## DECISION OF THE HEARINGS OFFICER

**CONDITIONAL USE / CLASS 3 SITE PLAN REVIEW / CLASS 2 DRIVEWAY APPROACH PERMIT / CLASS 1 DESIGN REVIEW CASE NO.: CU-SPR-DAP-DR20-06**

**SUMMARY:** Development of a new two building apartment complex with 24 dwelling units.

**LOCATION:** 5600 Block Woodside Dr SE, Salem OR 97306

## SDR3

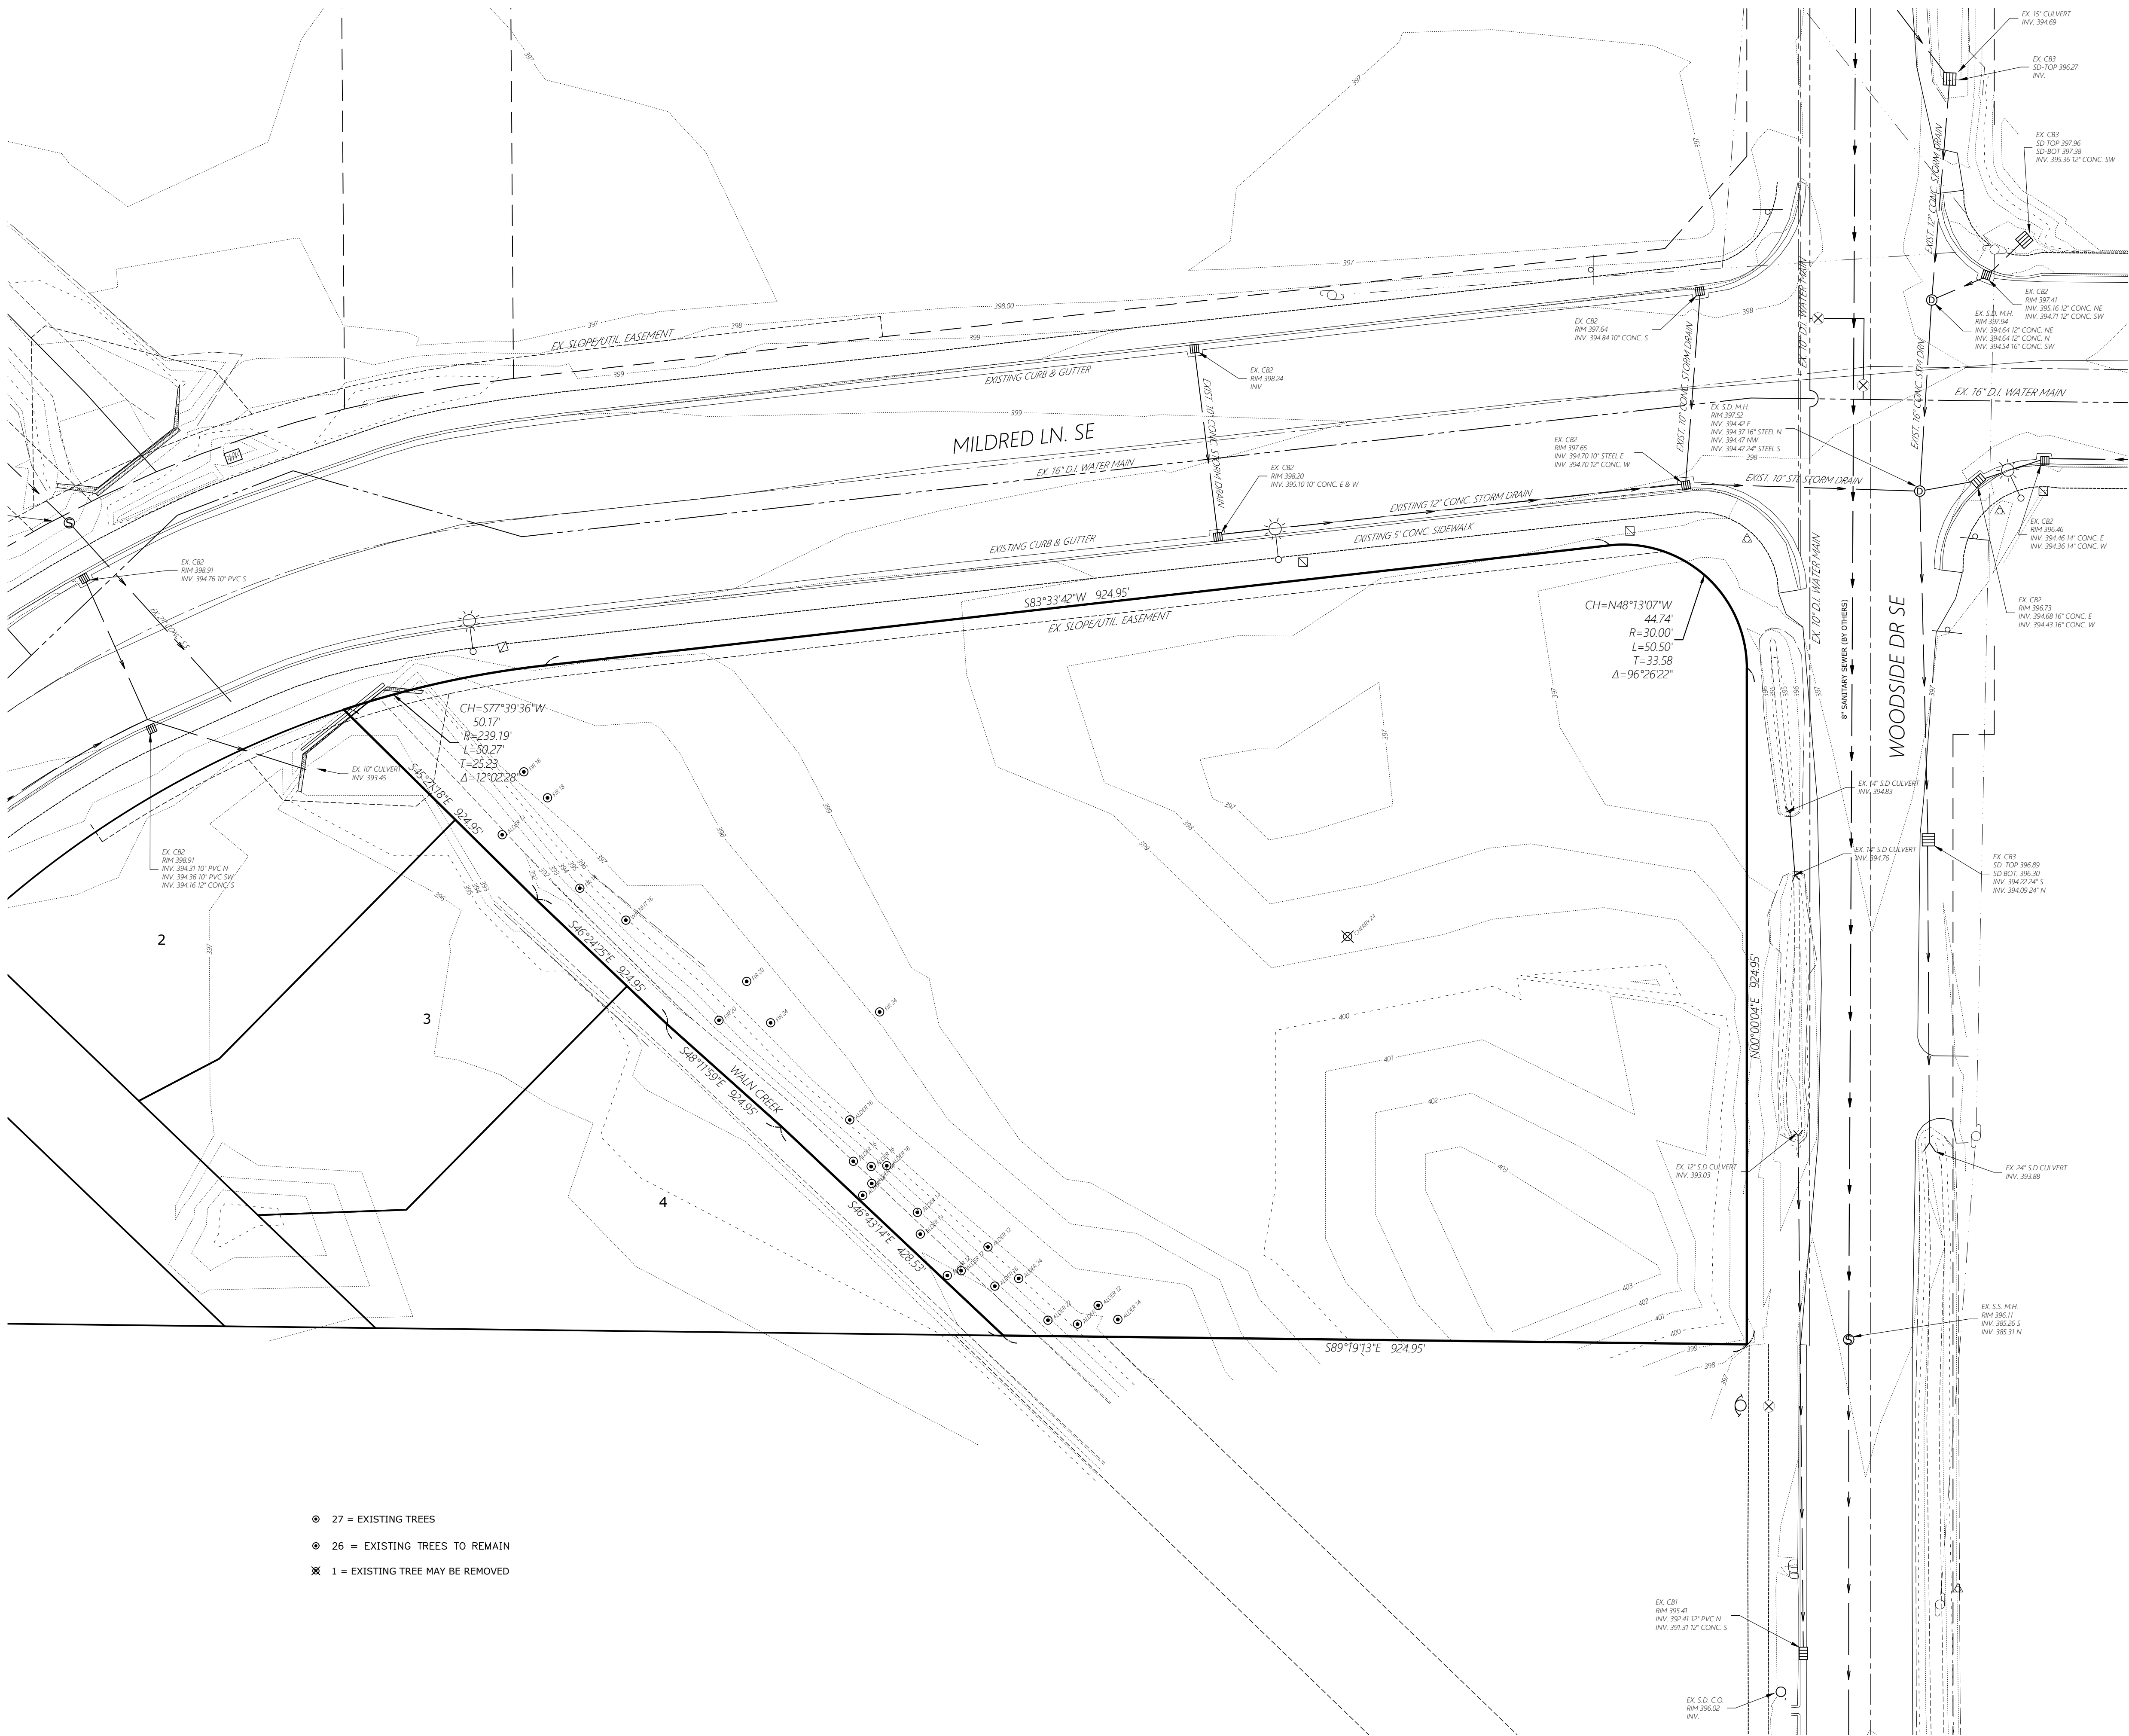
**Finding:** The Hearings Officer notes that the applicant's proposed site plan does not match the proposed landscape plan. The proposed landscape plan eliminates one off-street parking space from the site plan, and in its place is a landscape island as required by SRC Chapter 702. To ensure that this standard is met, the Hearings Officer imposes the following condition of approval:

**Condition 5:** Prior to building permit issuance, the proposed site plan shall be updated to include the additional landscape island shown on the landscape plans.

**L2.1**

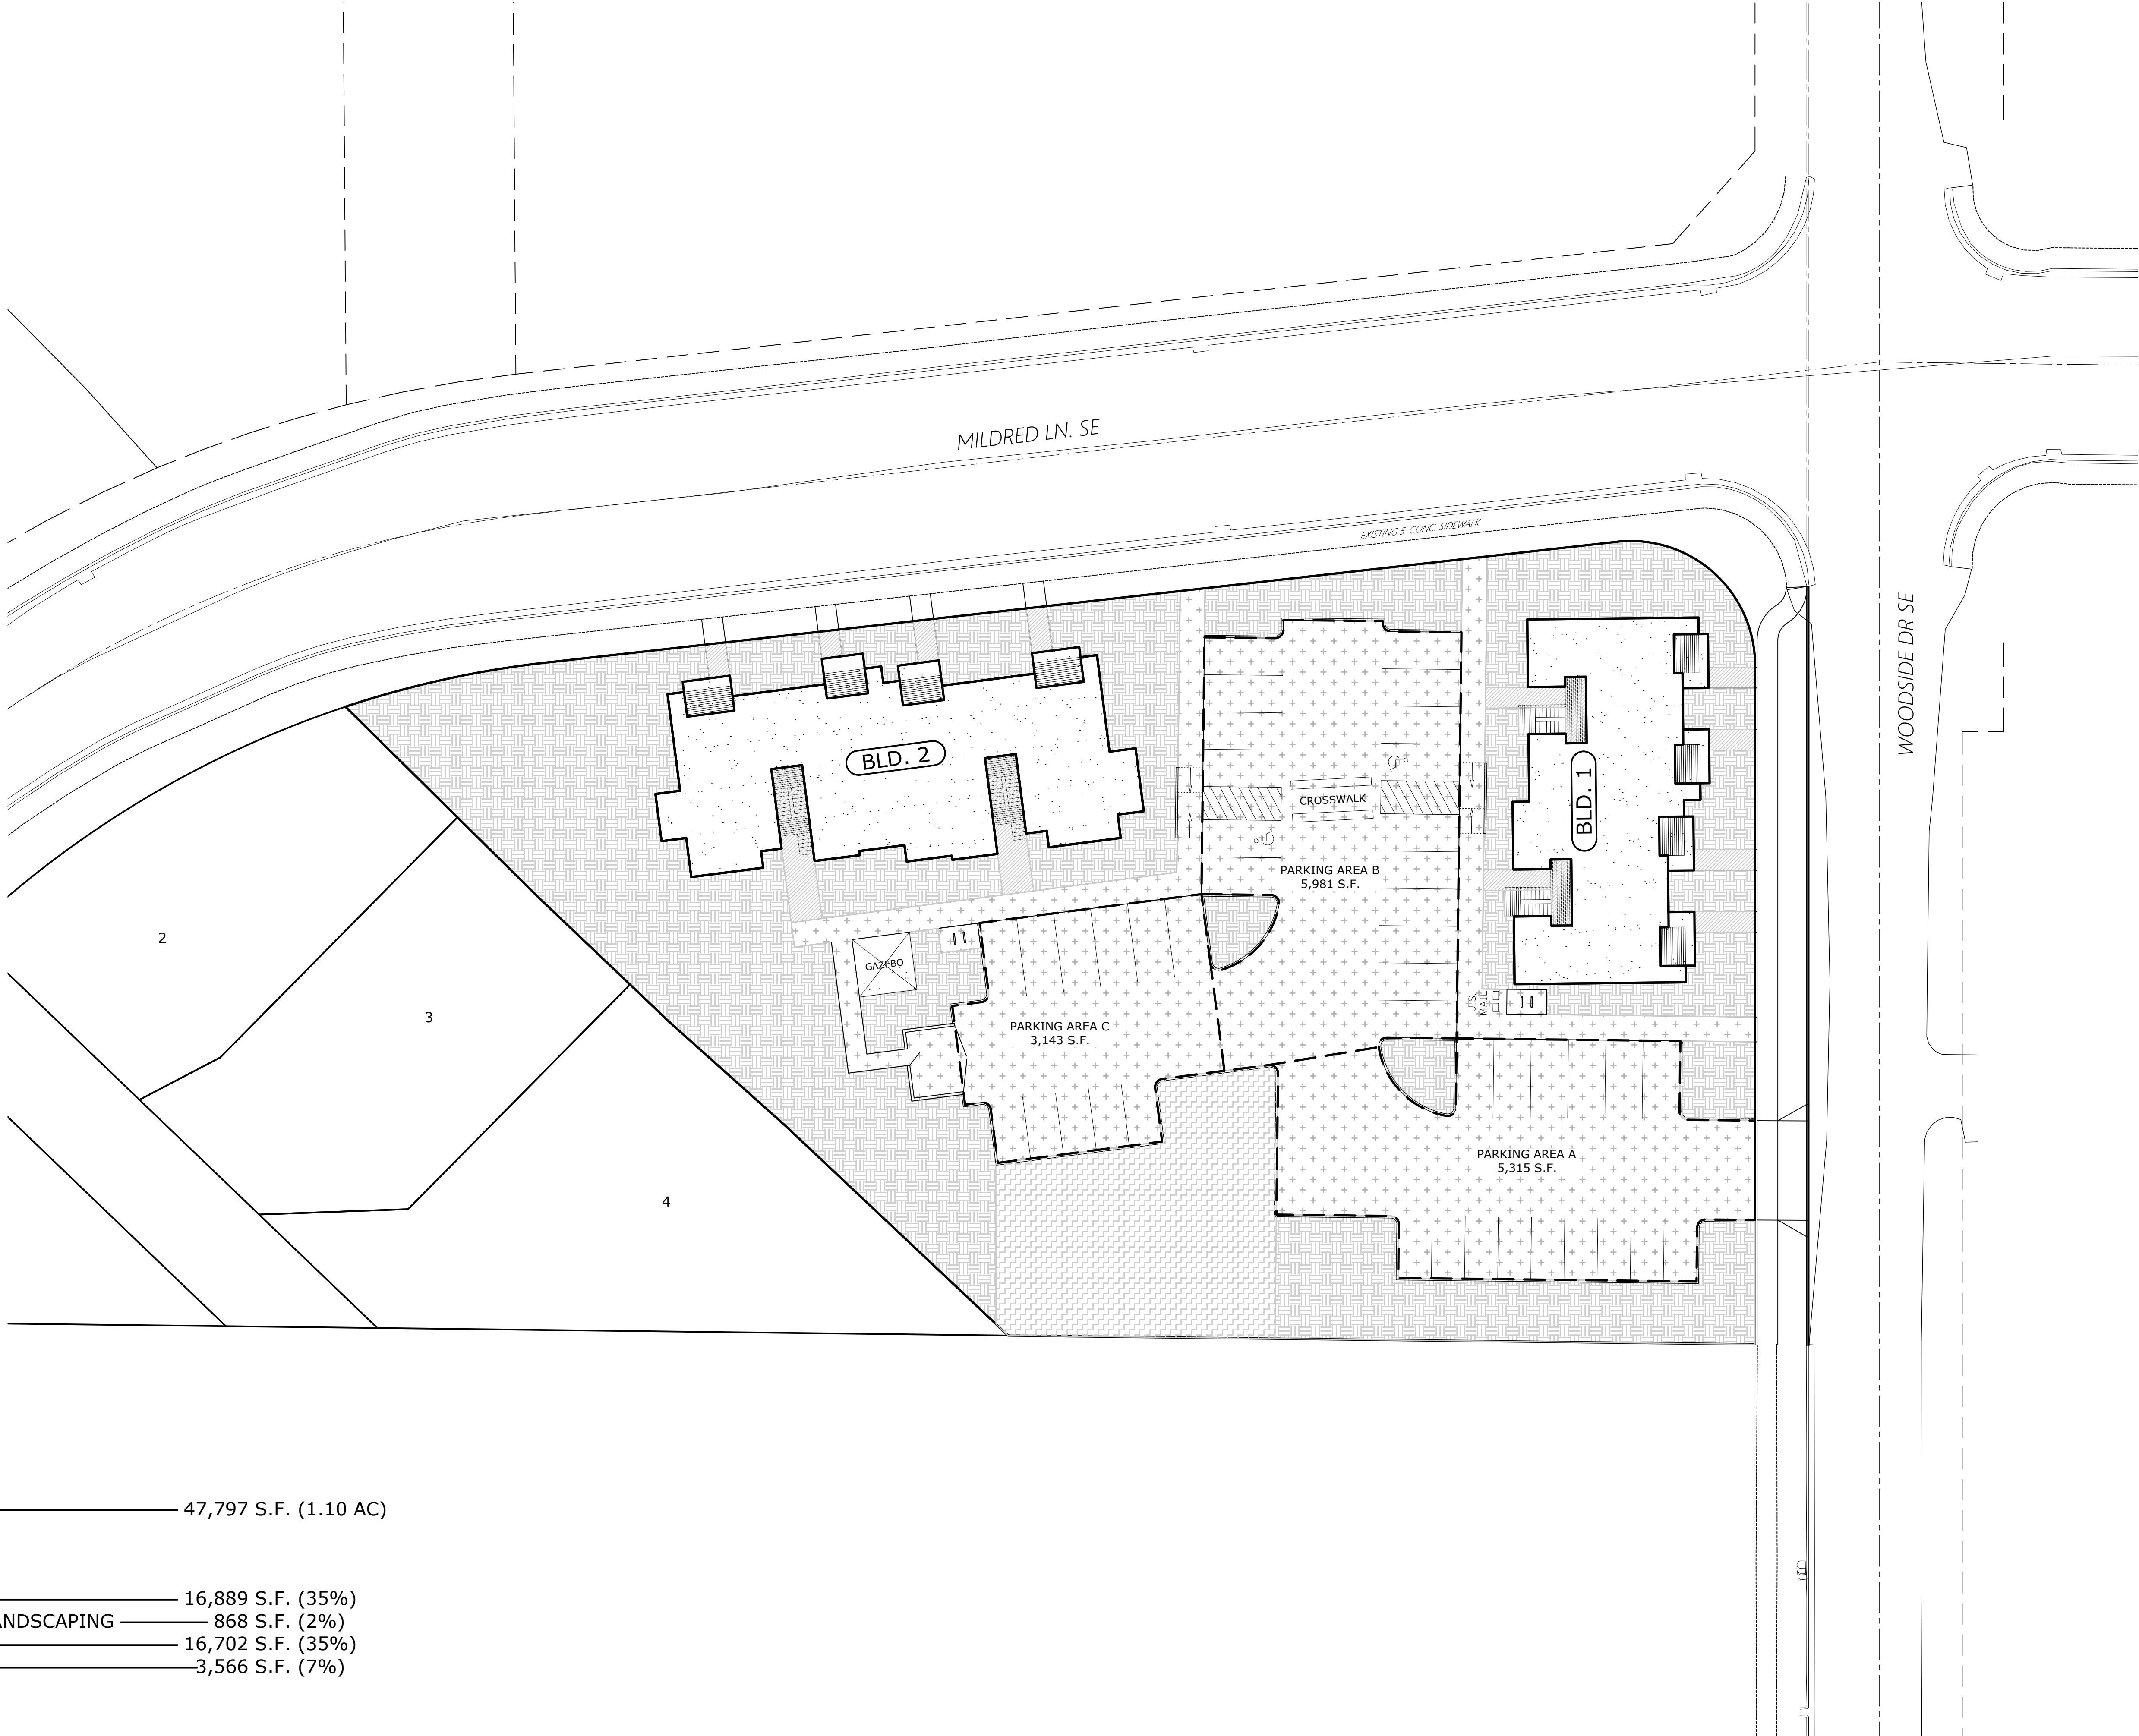
**Finding:** The Hearings Officer notes that the landscaping plan provided demonstrates at least two plant units will be installed at each shared entrance, satisfying this standard.

**Finding:** The Hearings Officer notes that the landscaping plan provided demonstrates at least ten plant units of trees per 60 linear feet of exterior building wall are to be planted on each side of the proposed buildings, satisfying this standard.

**Finding:** The Hearings Officer notes that the landscaping plan provided demonstrates at least one plant unit of shrubs per 15 linear feet are to be planted on each side of the proposed buildings, satisfying this standard.

**Finding:** The Hearings Officer notes that the parking area is approximately 385 linear feet, requiring eight canopy trees. The landscaping plan indicates nine canopy trees along the perimeter of the parking area. The parking area contains 41 parking spaces, requiring 3 planter bays at least nine feet in width. The landscaping plan indicates at least three planter bays, nine feet in width, each with a canopy tree. The Hearings Officer finds that the application satisfies this standard.
